**SAN ANTONIO WATER SYSTEM**  
**NORTHEAST SERVICE CENTER – PARKING LOT ADDITION**

**SAWS JOB NUMBER #12-7701**  
**SAWS SOLICITATION #B-12-038-DD**

**ADDENDUM NO. 1**  
**June 22, 2012**

SAWS JOB NO. 12-7701  
 NORTHEAST SERVICE CENTER  
 PARKING LOT ADDITION  
 (54" CASING PROFILE)

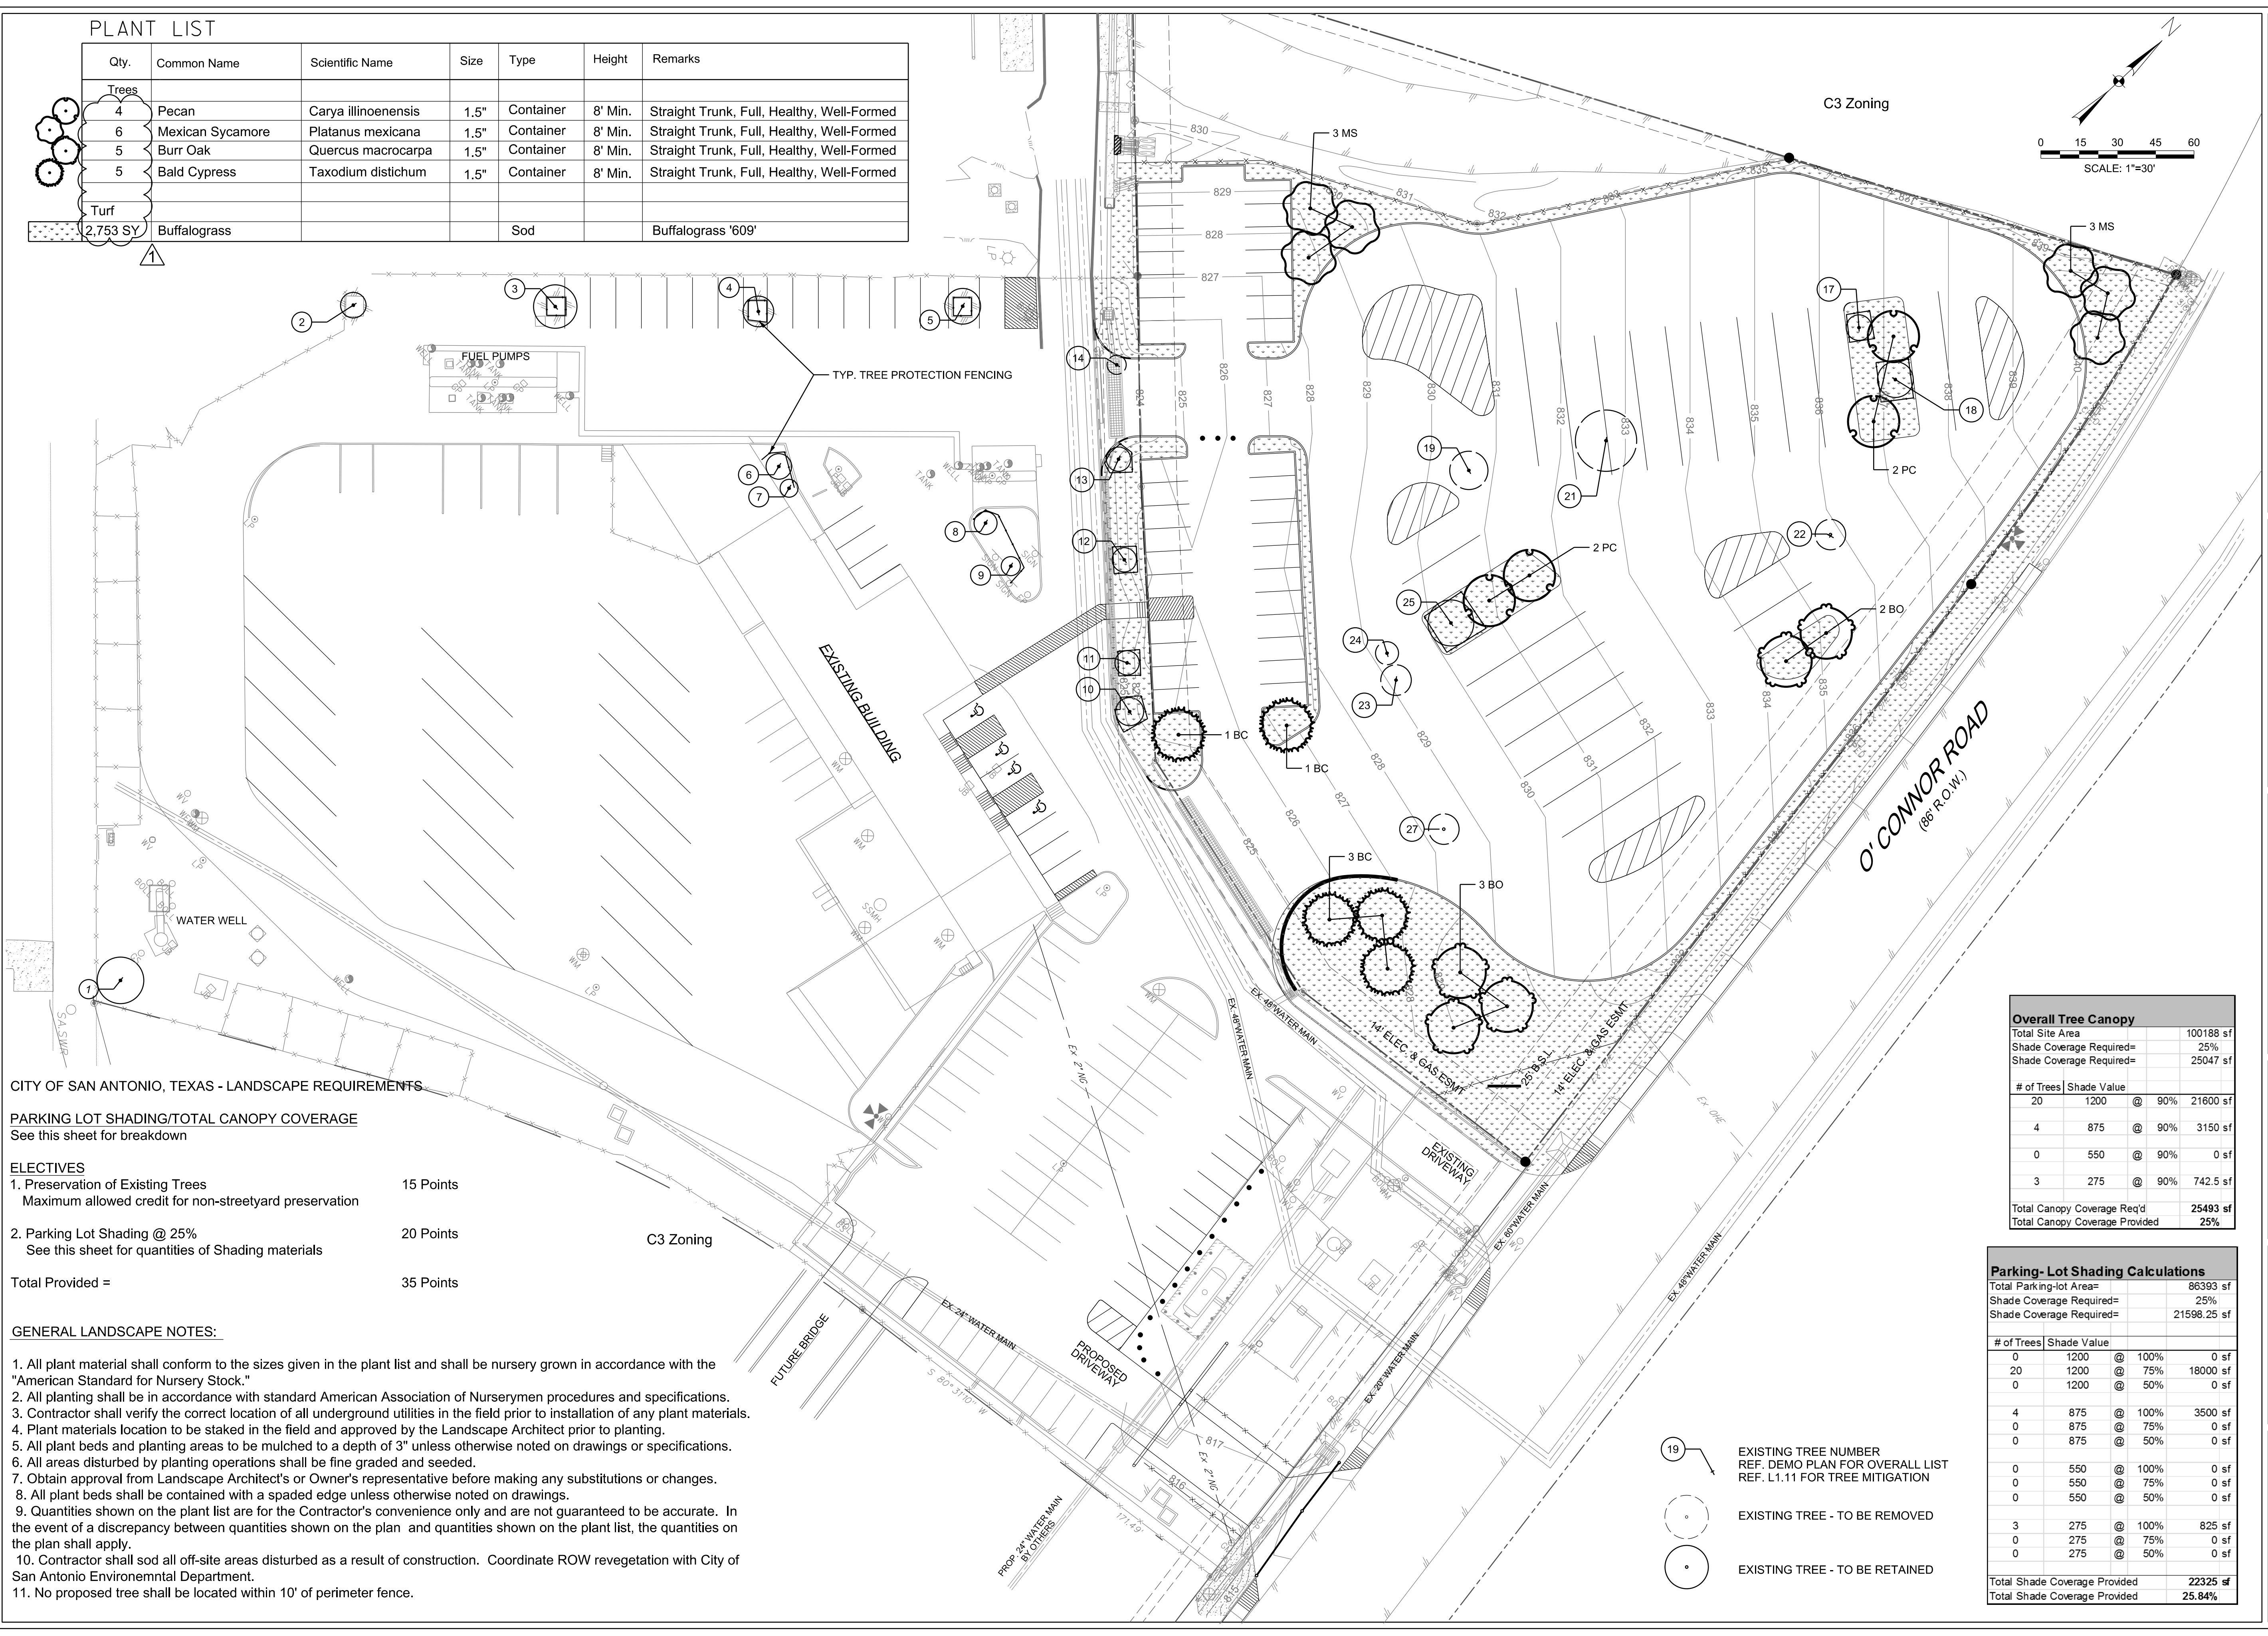
**Sheet C1.31**

"Added new sheet C1.31 '54" Casing Profile'."

Project No.:	28722
Issued:	MAY 2012
Drawn By:	DR
Checked By:	TF
Scale:	AS NOTED
Sheet Title	IRRIGATION PLAN
Sheet Number	L1:12

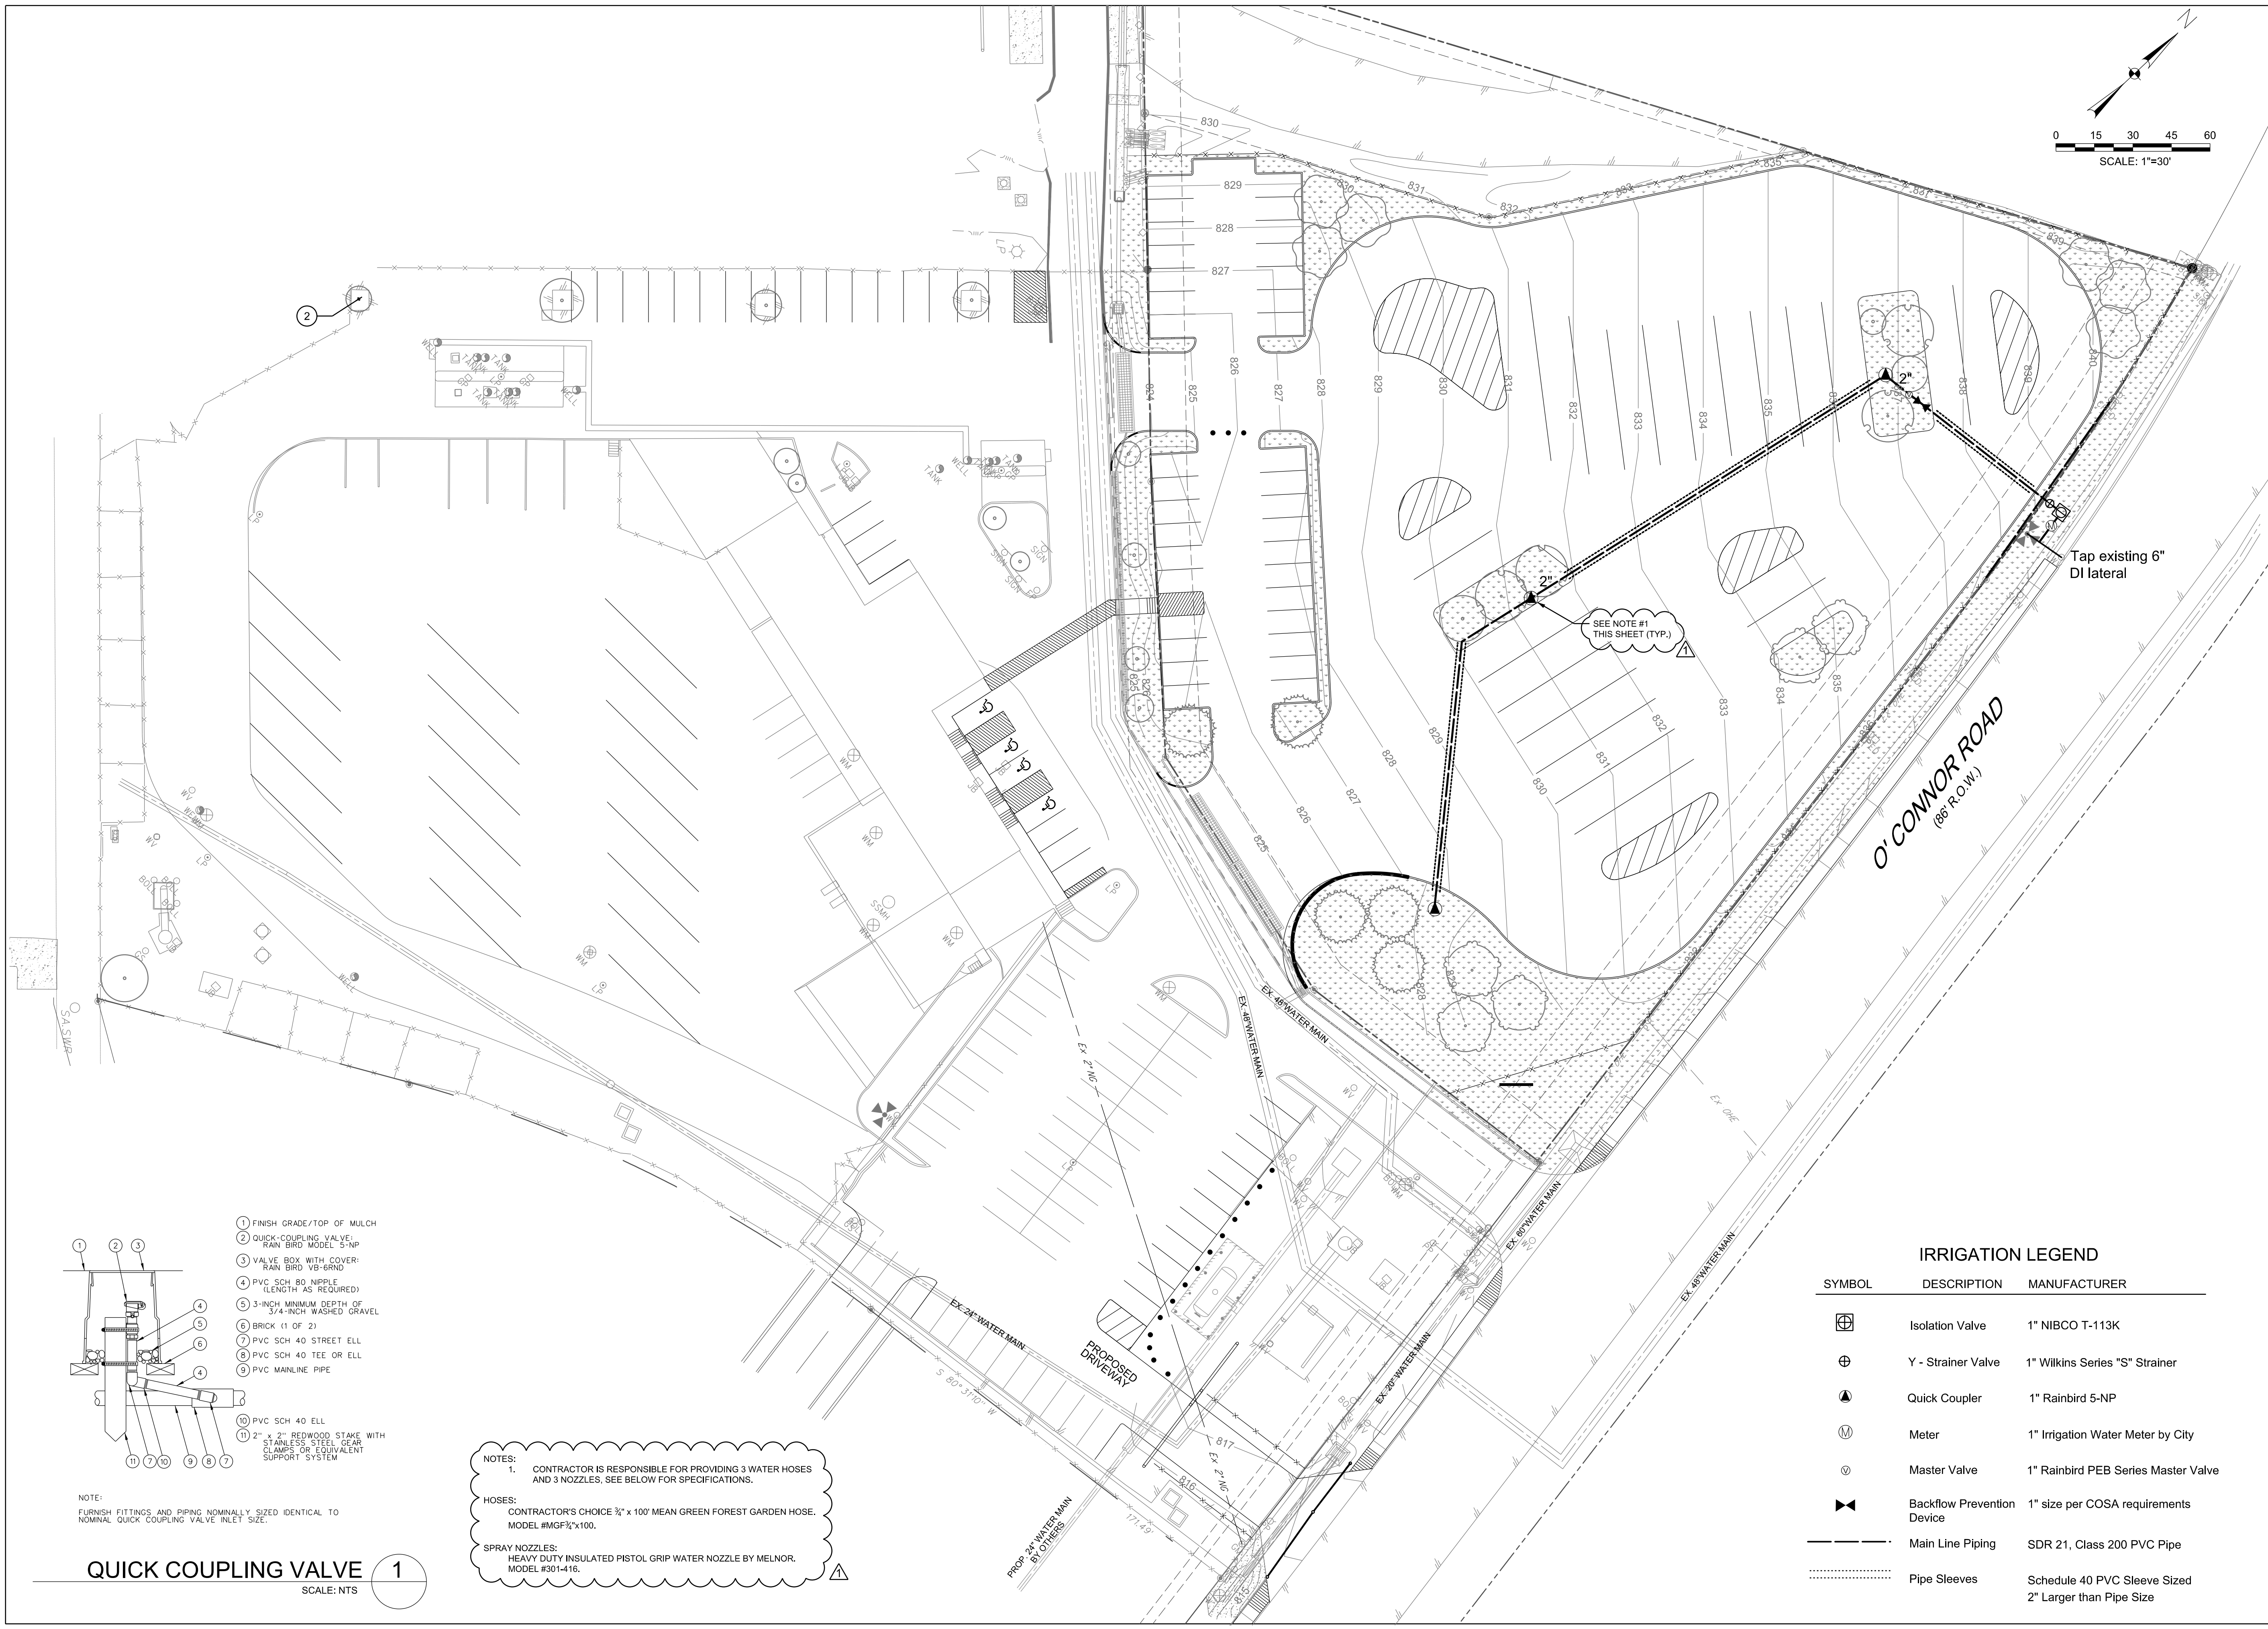
**Sheet L1.12**

"Added note #1"

NOTES:

1. CONTRACTOR IS RESPONSIBLE FOR PROVIDING 3 WATER HOSES AND 3 NOZZLES, SEE BELOW FOR SPECIFICATIONS.

HOSES:

CONTRACTOR'S CHOICE 3/4" x 100' MEAN GREEN FOREST GANDEN HOSE.  
MODEL #MGF3/4"x100.

SPRAY NOZZLES:

HEAVY DUTY INSULATED PISTOL GRIP WATER NOZZLE BY MELNOR.  
MODEL #301-416.

GEI Project No.:	SAWS12-006
Issued:	JUNE 1, 2012
Drawn By:	SG
Checked By:	BD
Scale:	AS NOTED
Sheet Title	PARKING LOT LAYOUT
<b>E-02</b>	
Sheet Number

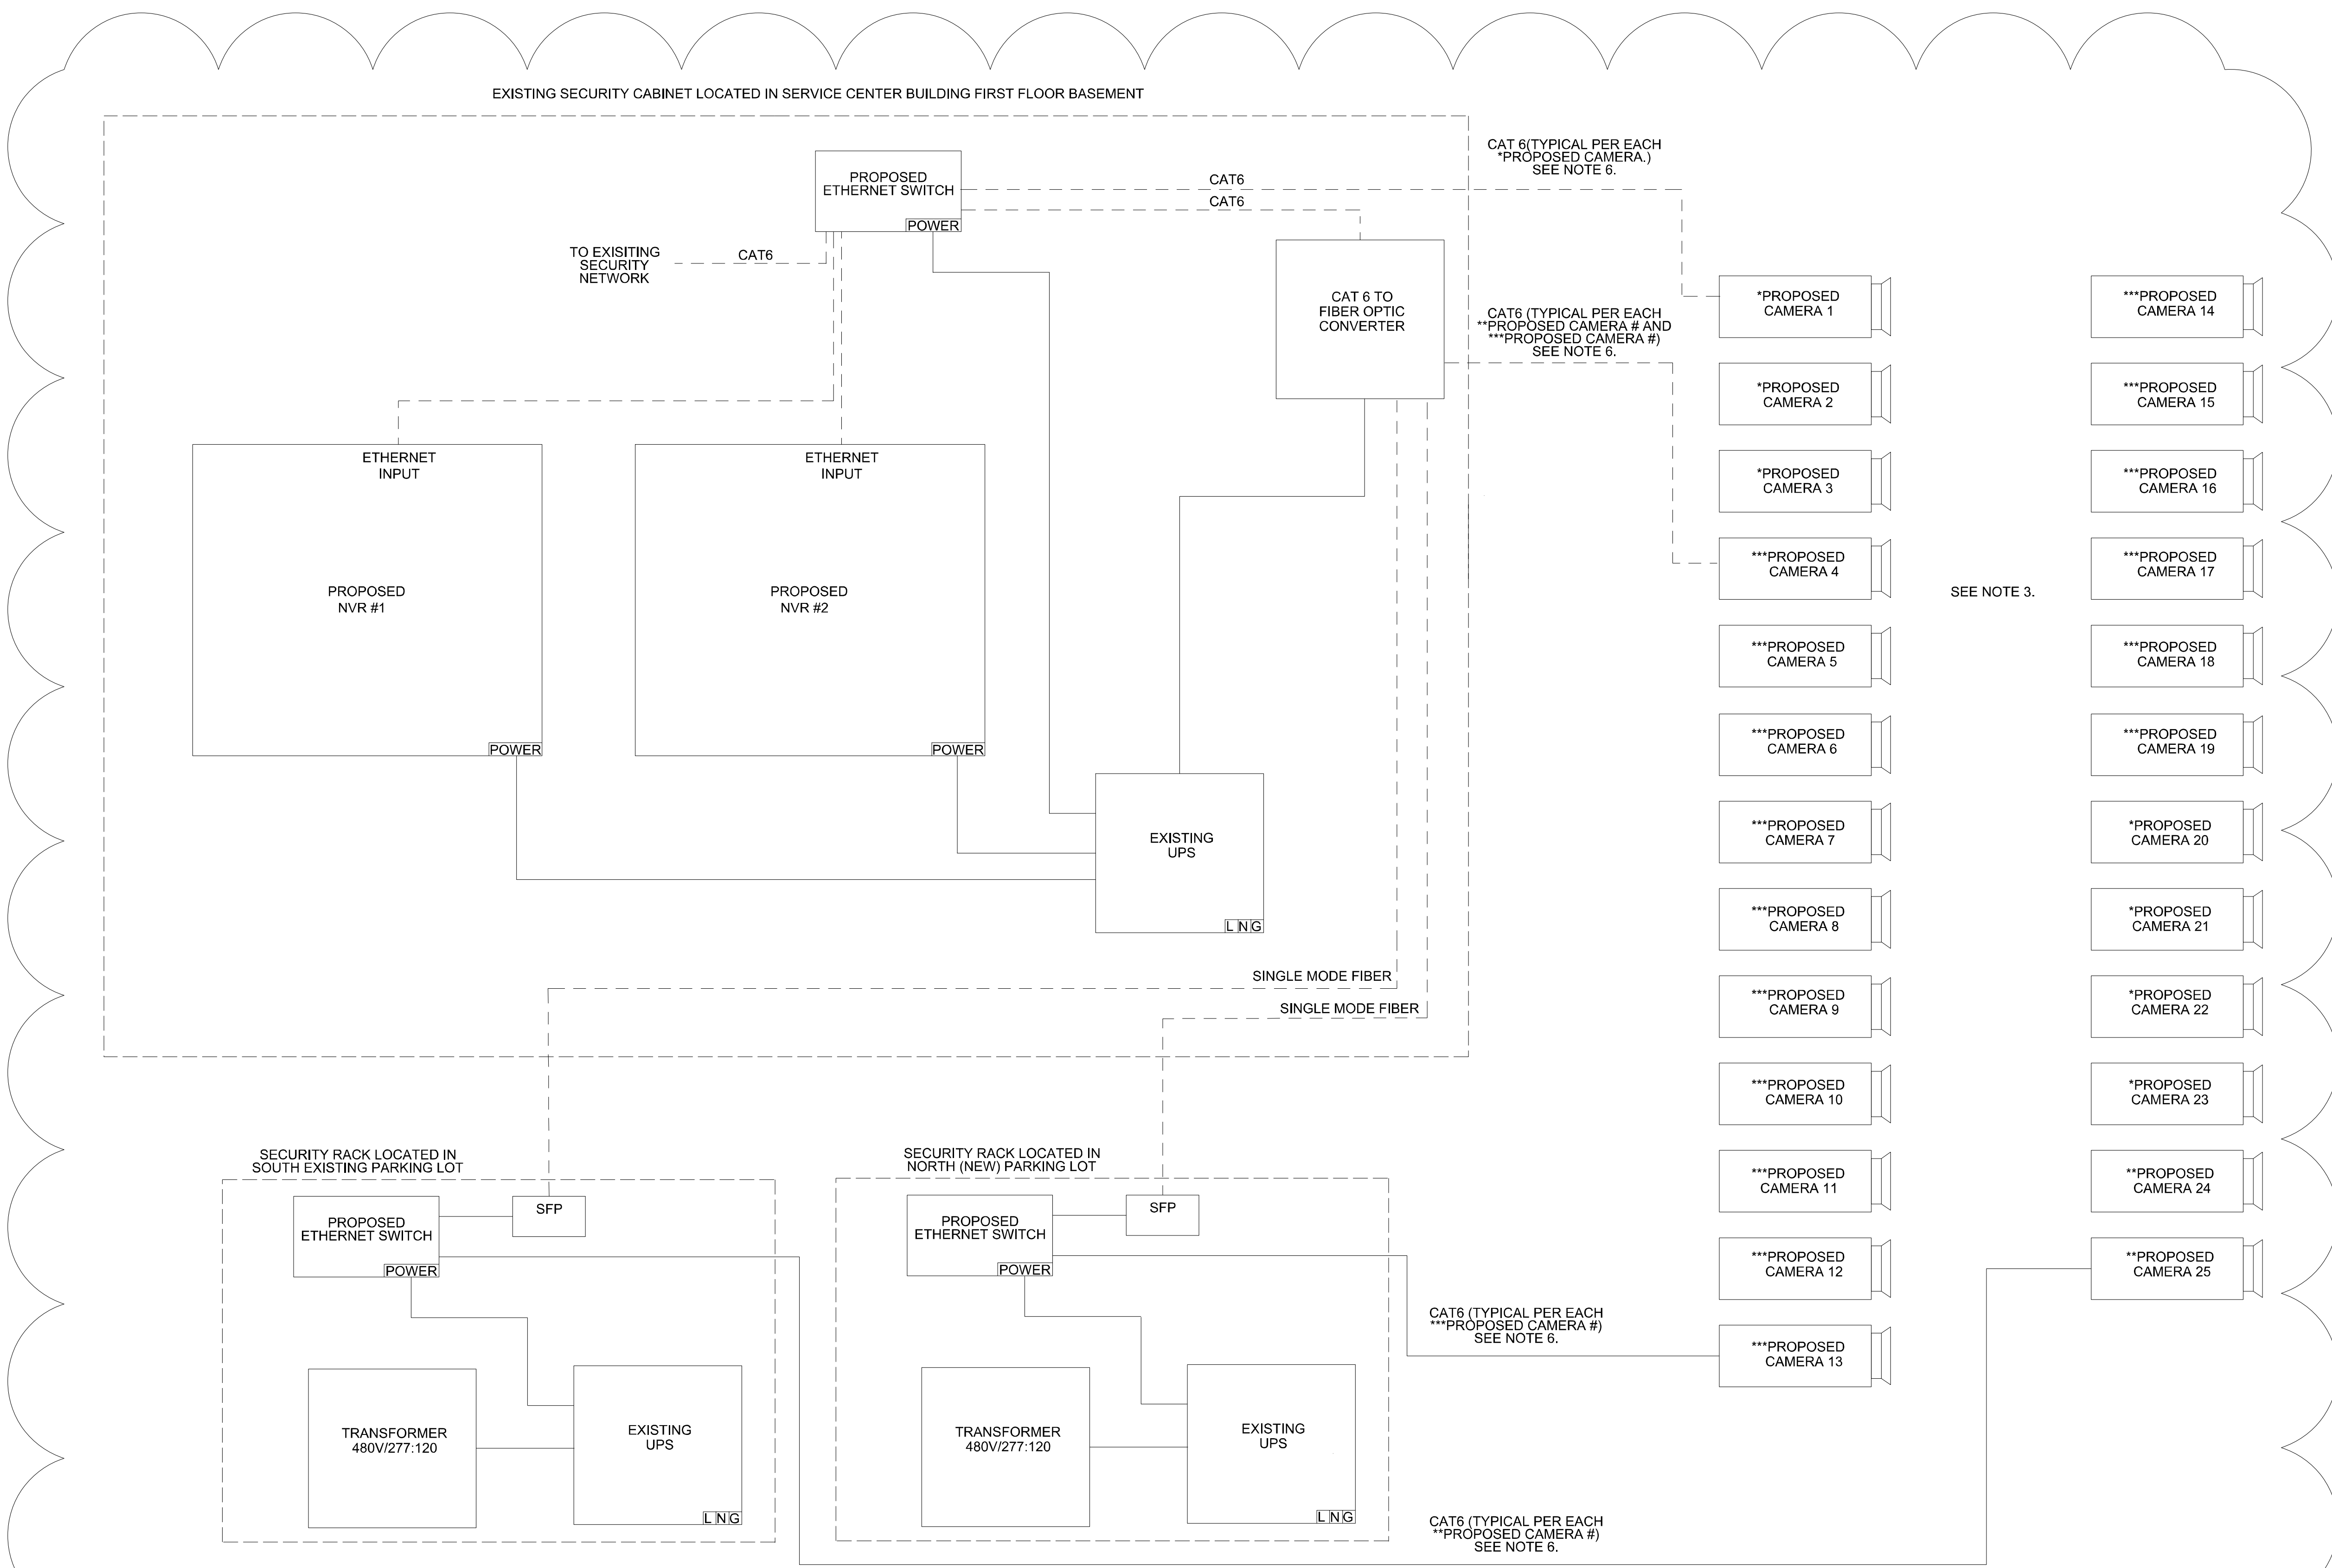
## **Sheet E-02**

**“Added handholes, electrical racks, electrical and security equipment”**
